SPIRE-RAL-PRJ-00624
10th April 2001 version updated in brown
24th August, 2001

GROUNDING and SCREENING PHILOSOPHY

SPIRE GROUNDING SCHEME PROPOSAL

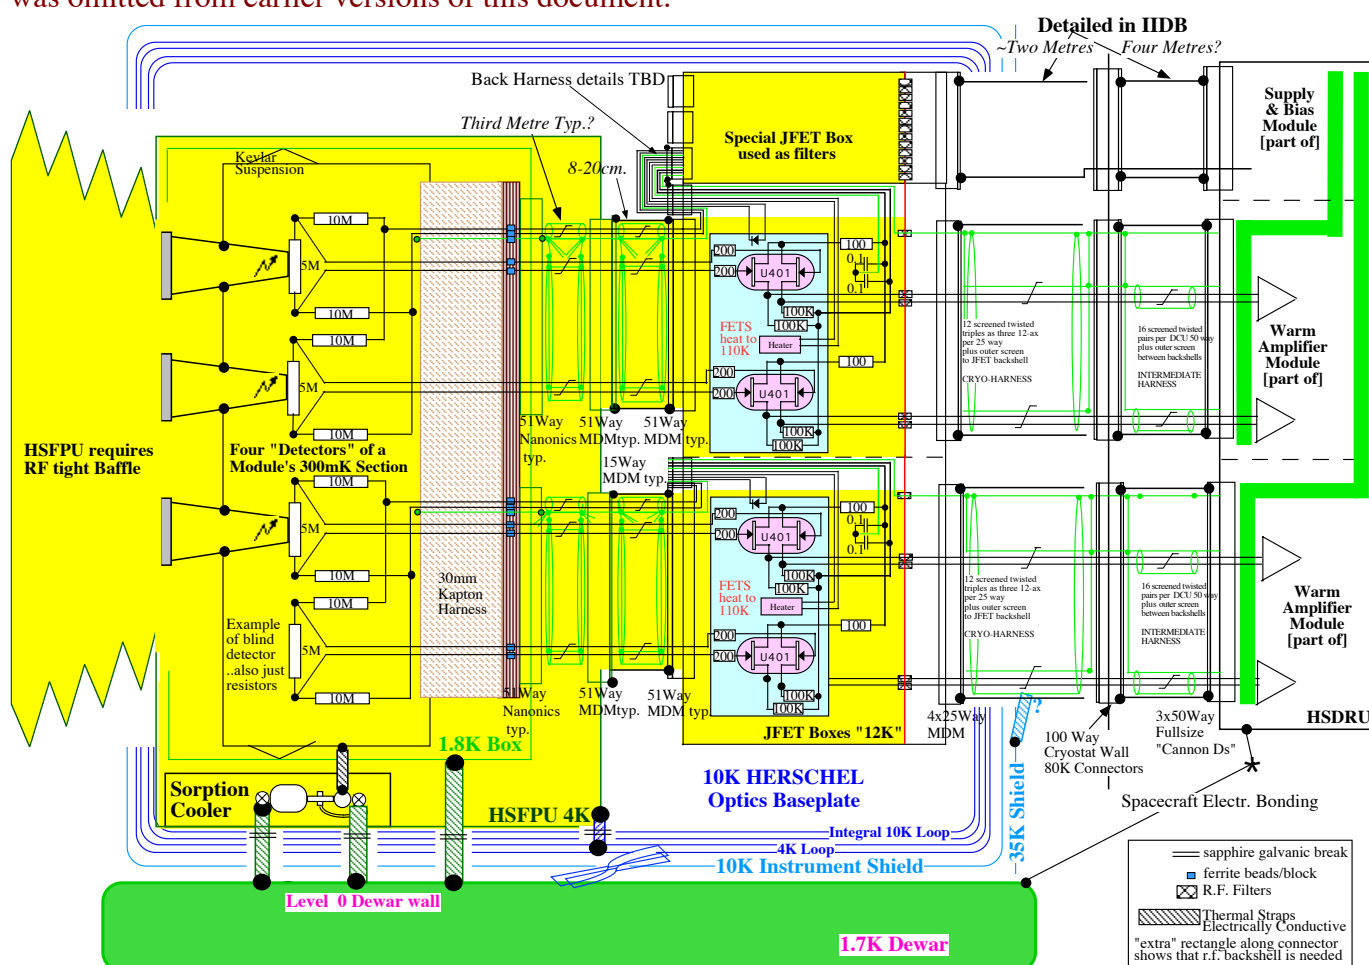
This is a very encouraging starting point. Comparing this with the grounding diagram, we can note the split between the spectrometer and photometer analogue grounds, G1+G5, versus G2+G6. The isolation of the Lock-In-Amplifier grounds from the Bias/FET power supply grounds is an improvement on my solid ground plane for each side. I would encourage the $\pm 9V$ powered high level analogue sections to be split into separate grounded sections as mentioned at the meeting and as shown by the dotted lines I've drawn in to the above. This should help keep the FPGA noise from propagating back to the analogue sections.

I do not think I should go further with the specifics until it is agreed how the power supplies, prime and redundant, are configured from the FCU into the DCU.

- keeping the low noise LIA inputs clean may need screens between the modules and even mesh cages connected to analogue ground over their $\sim x300$ d.c. restoring pre-amplifier sections.

- Clearly keeping the PSD and offset selection switching noise out of the inputs is non-trivial, because in reality each LIA combines analogue with some slow speed digital function.

- The LIA grounding might best keep its analogue and digital functions on two separate ground-planes joined once on each module, to look like one ground from outside.

- Coupling these slow speed switching functions into the LIA from the prime and redundant FPGAs may best be accomplished using opto-couplers, one per side per LIA to add robustness and permit the easy O-Ring of signals.

- keeping digital noise out of the bias generators is equally demanding and could take a similar approach because, although signal levels are all much higher, ground currents are equally destructive of performance if they reach the bolometers. One would suggest a detailed discussion between the electronic designers to choose a configuration that keeps the digital exchange of information from the FPGA to the bias generators to a minimum.

- the DCU Faraday cage must be well closed and any signals taken outside it and back in again via harness "internal" to the unit must be identified, fully screened, and generally analysed.

SPIRE PSU_DRCU Implementation

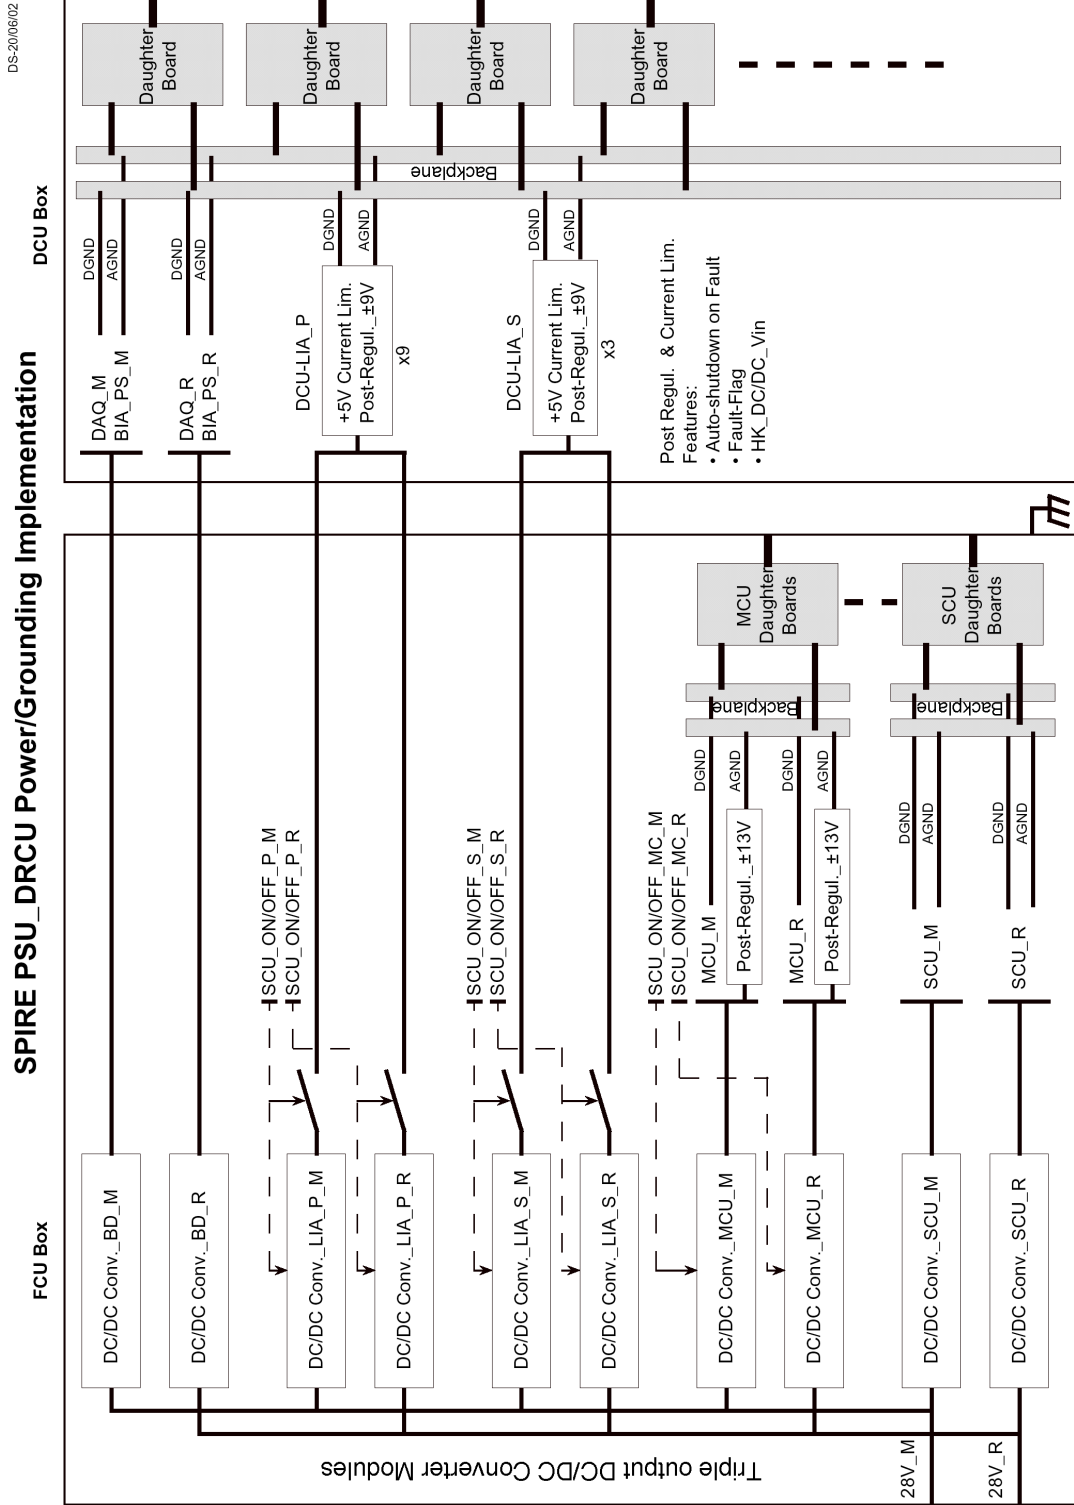
There are five Primary(Main) convertors on the Primary(Main) 28V supply and similarly on the Redundant. For those DRCU units which have Primary and Redundant sides these run the corresponding sub-systems. For the LIAs, which are non-redundant, the secondary grounds all remain connected but the power rails are relay connected/disconnected as needed, depending on which power module(s) is /are active. ON-OFF is coordinated through the SCU which enables or disables power module oscillators [which implies some transient state current values on the 28V bus that the monitoring S/W will need to know about!]

To note in passing, the number of power modules would not seem to be an overriding driver for CEA since they decided not to take up the offer of 5V power from the DPU for the logic and interfaces. Note also that rather than dioding together S/C supplies to power non-redundant supplies feeding non-redundant LIA systems [maybe split into smaller groups than spectrometer/photometer], both Prime and Redundant supplies are used for such systems [in a way presumably akin to CEA's earlier decision based on single point failure analysis not to make the bolometer biases all non-redundant and more grouped.]

It's not yet clear whether a “triple output” on the drawing means three separate windings with three grounds and as many taps as may suite, or whether it means three voltage rails. Either way, I only say above “possible to proceed” because I note that at any one time only one module is active and powering the DCU despite its power requirements. Also whilst the FCU merits its own supply for biases and digital I/Fs, the apparently more sensitive DCU does not. How good will the isolation be between the sections of the DCU identified earlier in this document when in either of the spectrometer and photometer

mode they are all run from one power supply module which does not have any inter-winding screens. If it is an error that the top two power supplies shown above stop in the FCU but in fact they power the DCU, then again I wonder whether noise can be kept off the critical bolometer bias secondaries and their grounds (there's secondary regulation shown here) if the same convertor is also running lots of logic.

SINGLE DETECTOR DETAIL GROUNDING

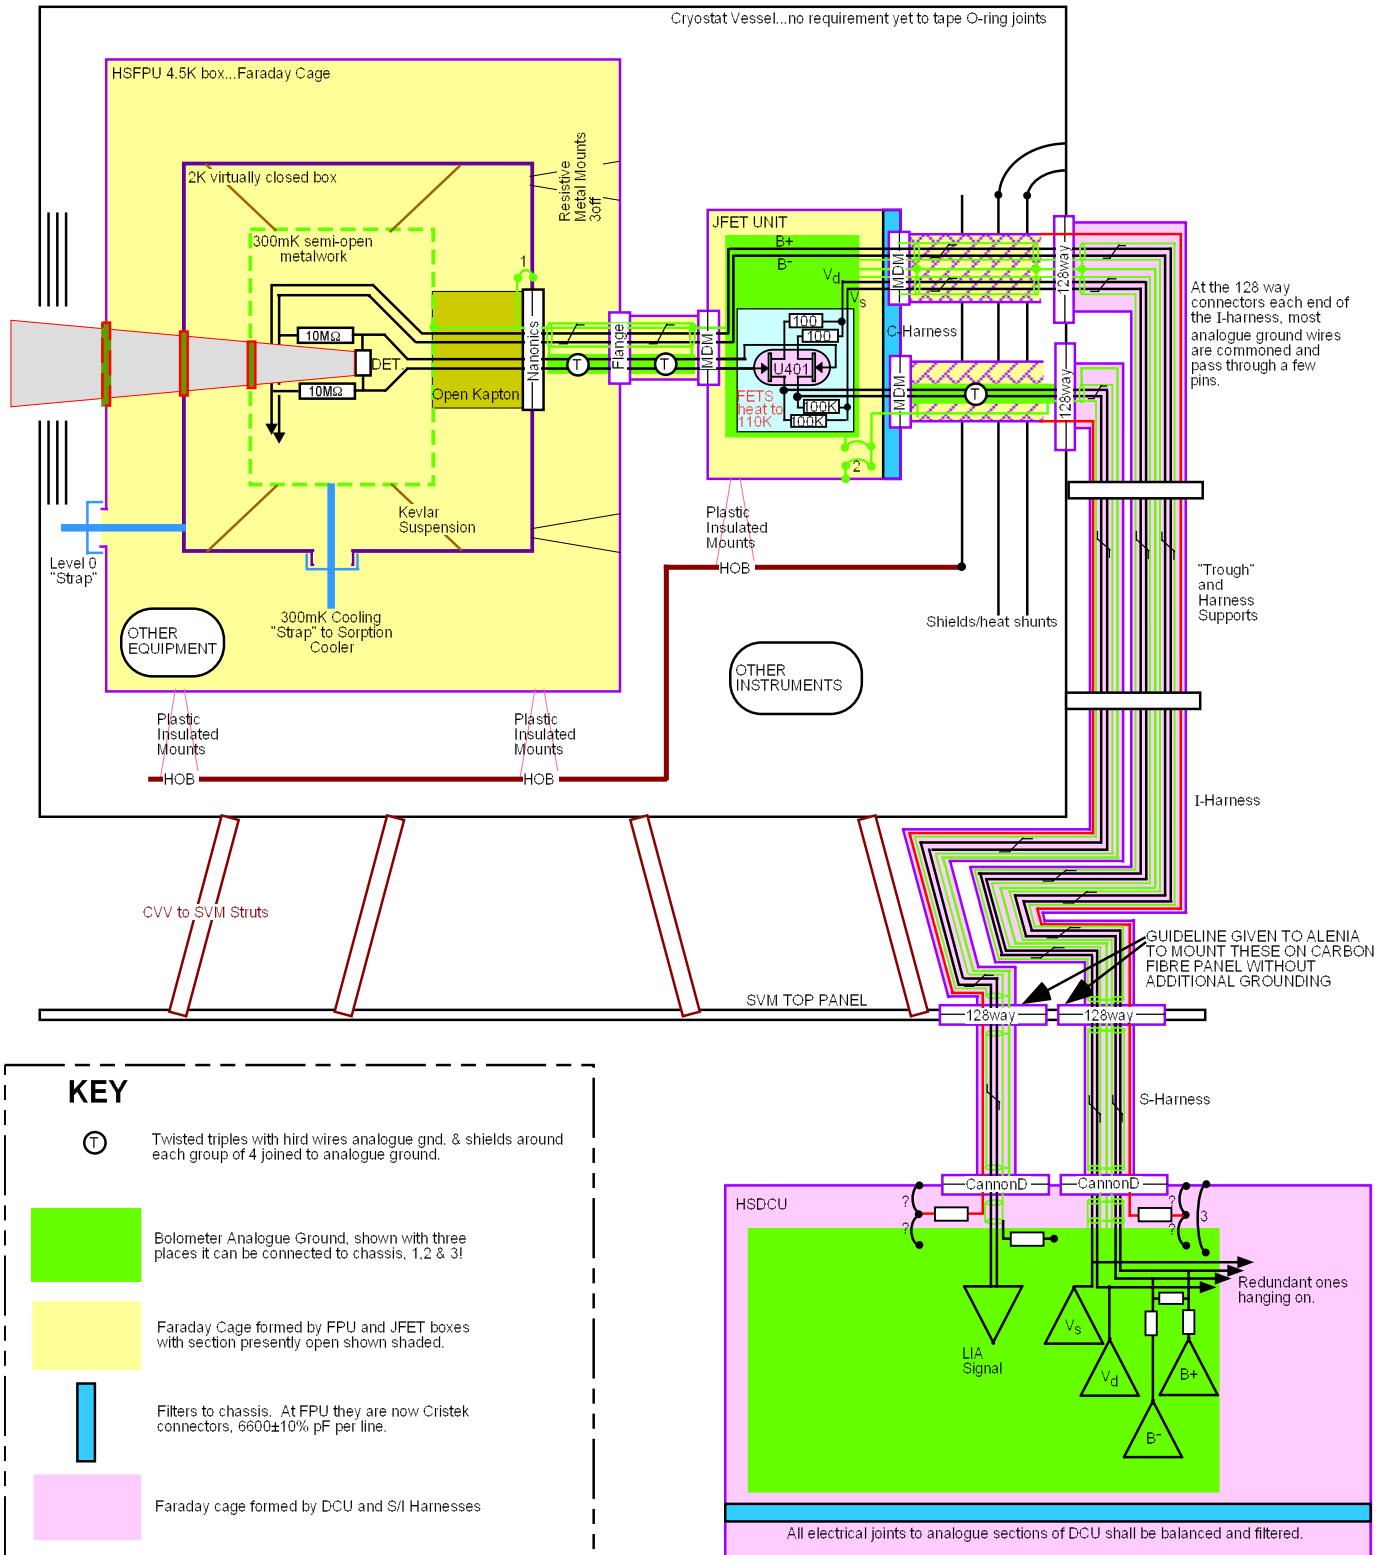
We really only have a choice of two points to link analogue ground and chassis grounds. This is because after the outer screens on the inner parts of harnesses F1-15 (i.e. inside the FPU Faraday cage) were removed for thermal reasons the analogue ground links to the metalwork at point 1. are needed anyway just to hold down the 2K boxes properly. [One small point Jamie, JPL's 10209725 still shows a connector at the FPU wall (with a link wire) both of which I would understand have gone.] More importantly, the metalwork around the high-impedance detectors **is** then joined to analogue ground whichever point we link that analogue ground to the outer system chassis. **Berend: could you please estimate the electrical impedance of the 2K box mounts because we may require to increase this with some Vespel bushes, but if they achieve good thermal isolation they should have significant electrical impedance anyway.** So in some regard Viktor's concern is unfounded, but in my view it probably remains a concern because of the very low noise levels which Spire must achieve.

Even after linking at 1, we are still left with an analogue ground that is essentially floating except for stray impedances and gratuitous noise injections. If it were ideally floating we could ground it anywhere! Do we choose location 2 or 3?

But there is already a large (maybe 0.2 μ F) link from analogue ground to JFET box chassis due to the paralleling of connector pin capacitances, so at all high frequencies joining at point 3 amounts to joining in two places (a loop) which on the face of it is non-optimum. This and a realistic LIA CMRR should not be omitted from any analysis.

JFET output signals to be linked to the JFET local analogue ground so any induced current return to source. The resistor the other end of these lines in the DCU I would expect to be maybe 27K and just a “quietner”. However the option has been provided by JPL to unlink these analogue grounds at the JFET end and presumably hold them down somewhat harder at the DCU. As they would add to the LIAs’ input capacitance and return current to the wrong place I propose these links always stay fitted].

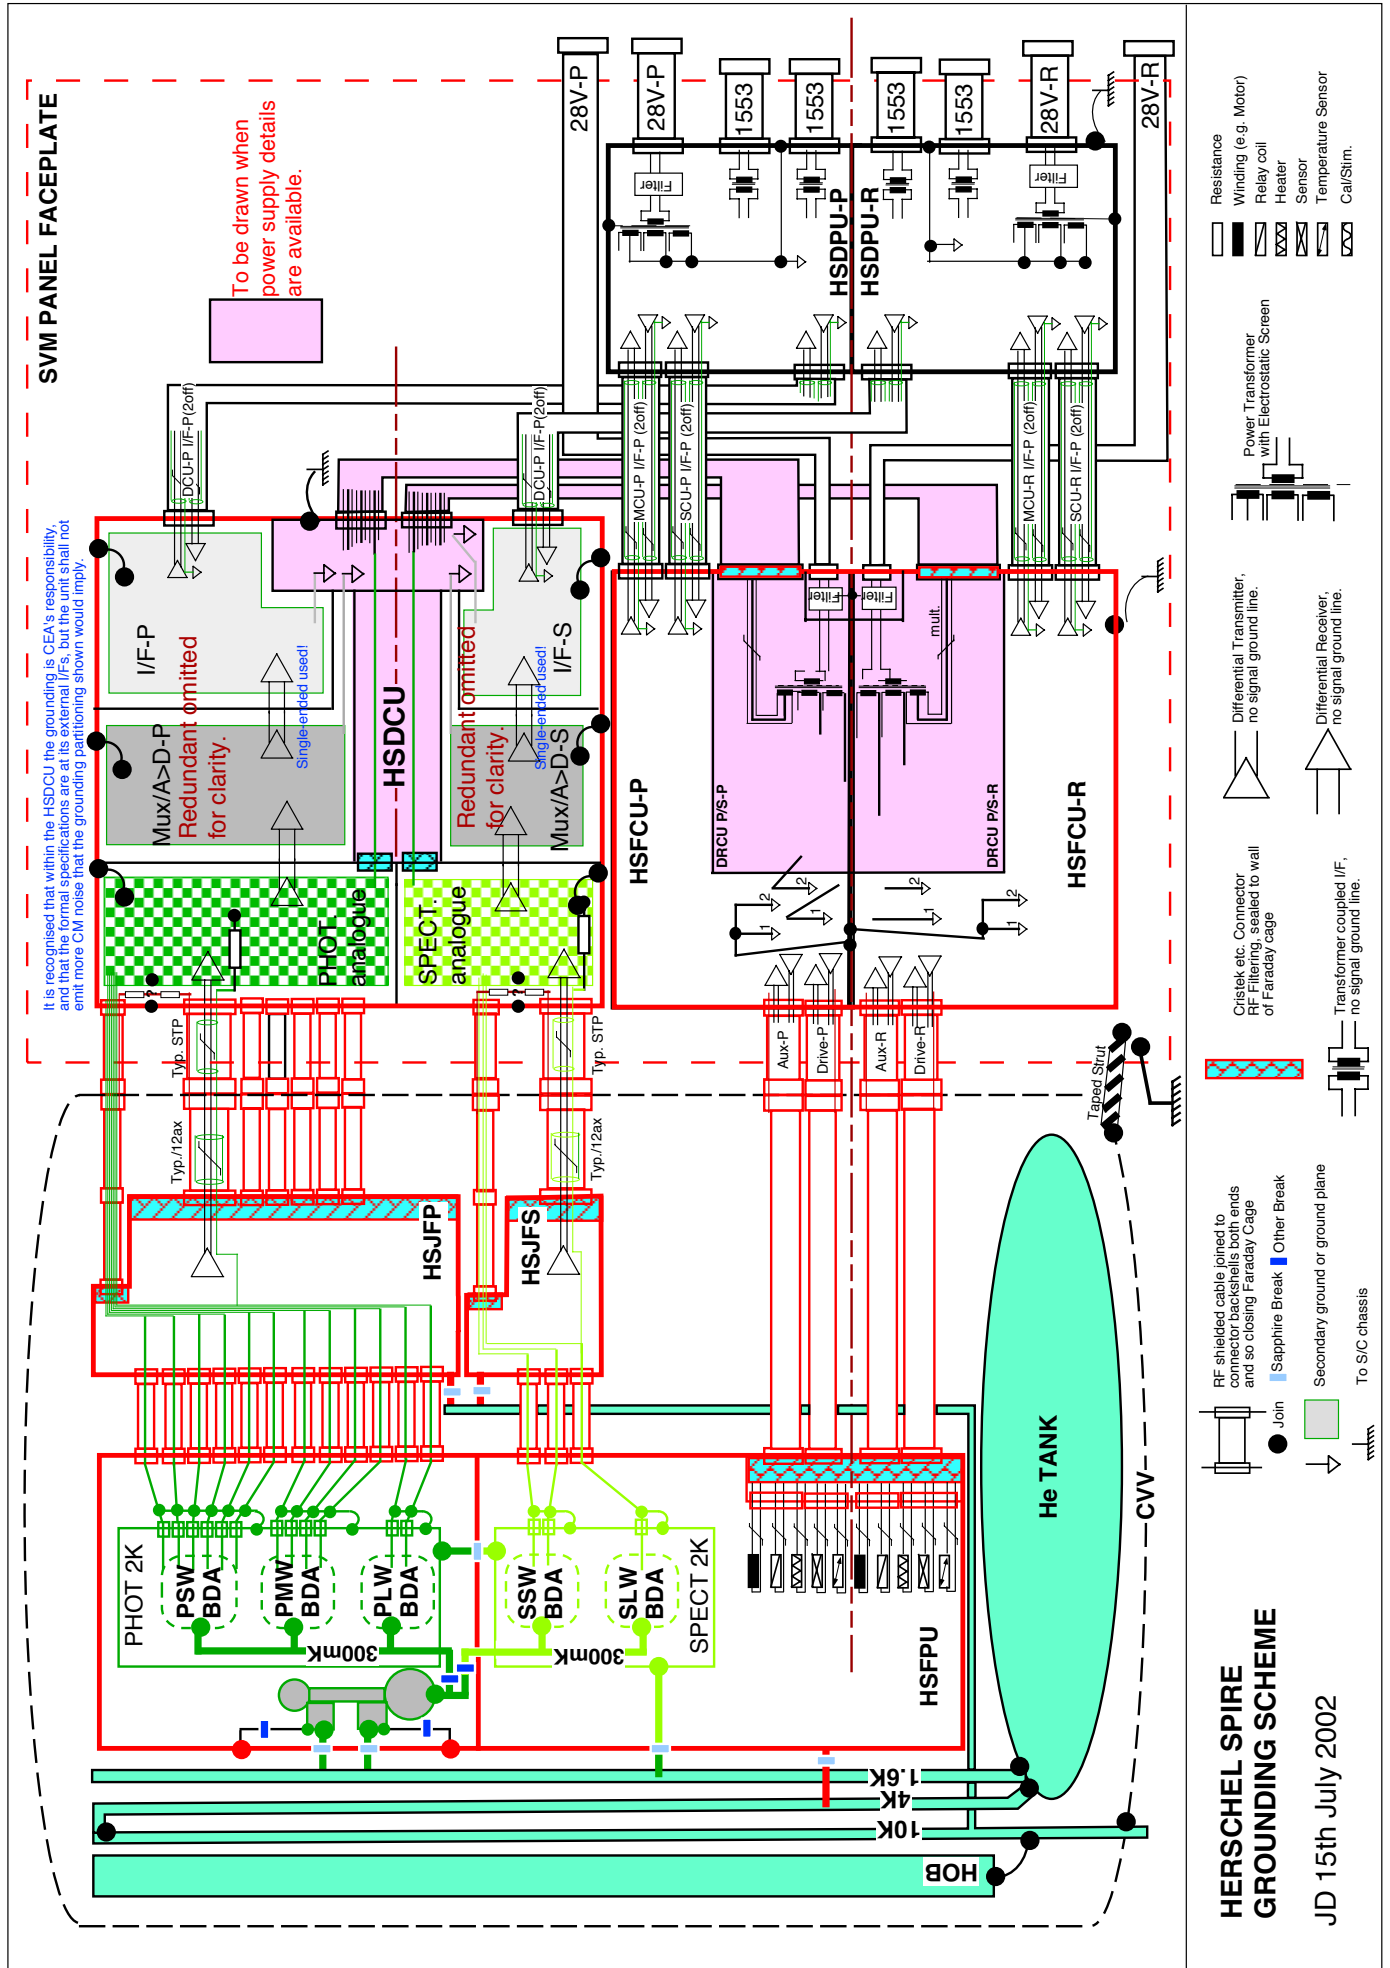
Changes since Overall grounding scheme version of 5th June.

Shutter removed.

Joined up instrument Faraday cage, see increase in red lines, by re-connecting shields at CVV wall.

Made resistors in Faraday shield link wires very narrow line because they would not be fitted in this scheme. I am assuming that the wire's fractional contribution to heatleak is small and that just running totally inside a Faraday cage they cannot be a source of pickup. Besides the test harness layup is made.

Removed all grounding option numbers as we are being forced at this stage to define one baseline.

Remove 2K detector box resistances to HSFPU chassis. This scheme requires the mountings be "isolated". Put isolation in 2K box link...would separate S/C strap be easier?

Reposition 300mK pump in drawing to show it more correctly on the Photometer side.

Put in 300mK ground breaks, distinguishing between sapphire and other ground breaks.

Simplify way backharness with bias grounds is drawn.

Add ground LINKS from LIA analogue ground to HSDCU chassis, previously only a "can we include as an option to try" link.

Change Spectrometer ground colour so no-one can assume it's the same as the Photometer!

Remove cross-feeds from Spectrometer LIA to Photometer, and visa versa, which where a left-over from old ideas.

Add note giving CEA flexibility within HSDCU.
